ECN for USB Power Delivery Specification Revision 3.2

Version 1.1, 2024-10

Title: Remove vEPRmax

Draft IEC 63315 ED1

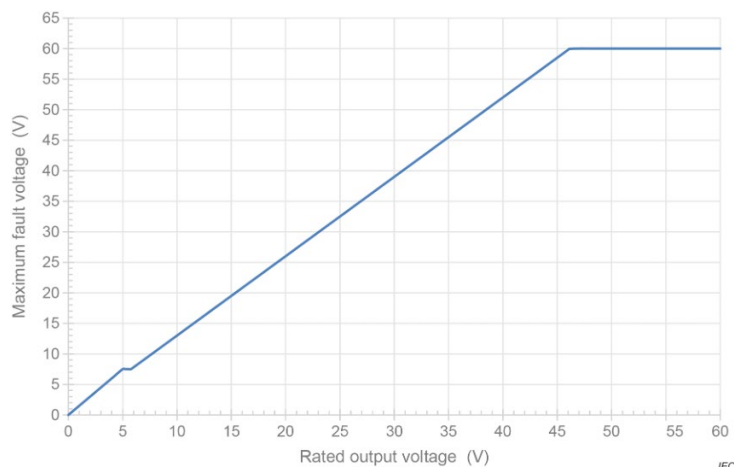
When not called out by a base spec, 150% maximum negotiated voltage $\leq 5V$
and 130% maximum negotiated voltage $> 5V$ functional safety requirement

Draft IEC 63315 ED1 references numbers from USB PD

Any values called out in a base spec override requirement in safety spec
Created requirements beyond standard 150% and 130% over-voltage

USB PD affects Safety rules for Sinks

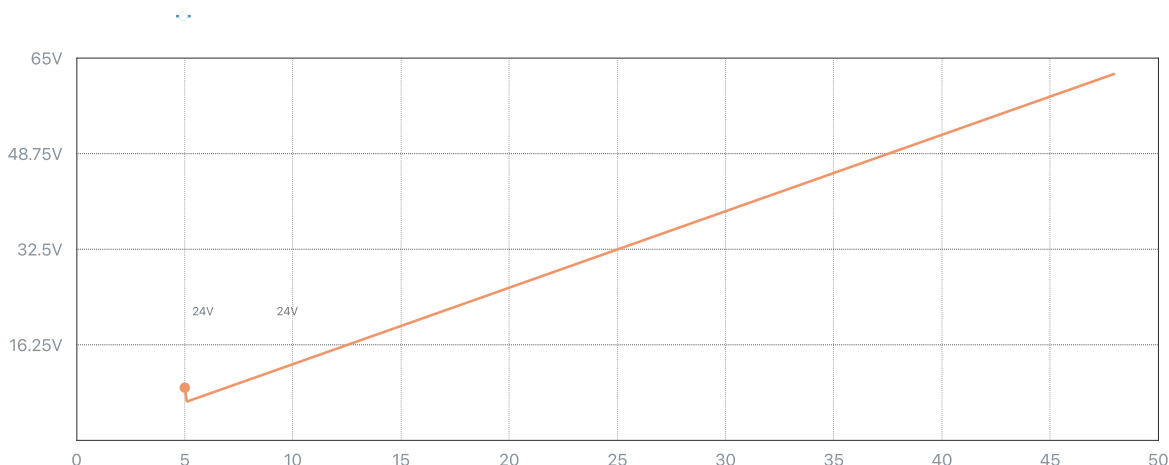
Current voltage requirements in USB spec based on maximum contract voltage

USB Spec Defined Sink Reliability

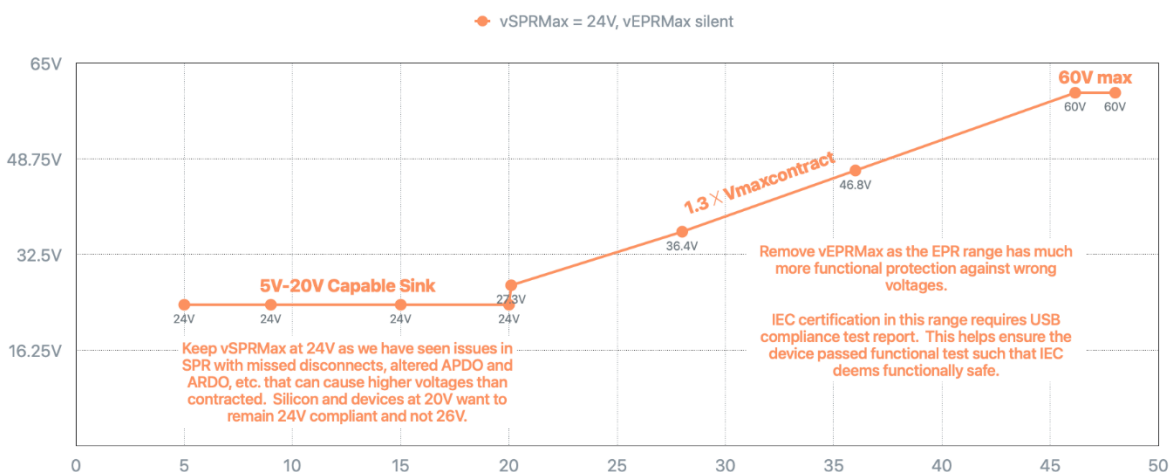
Proposal to keep vSPRMax = 24V and remove vEPRMax and let it default to IEC +30%
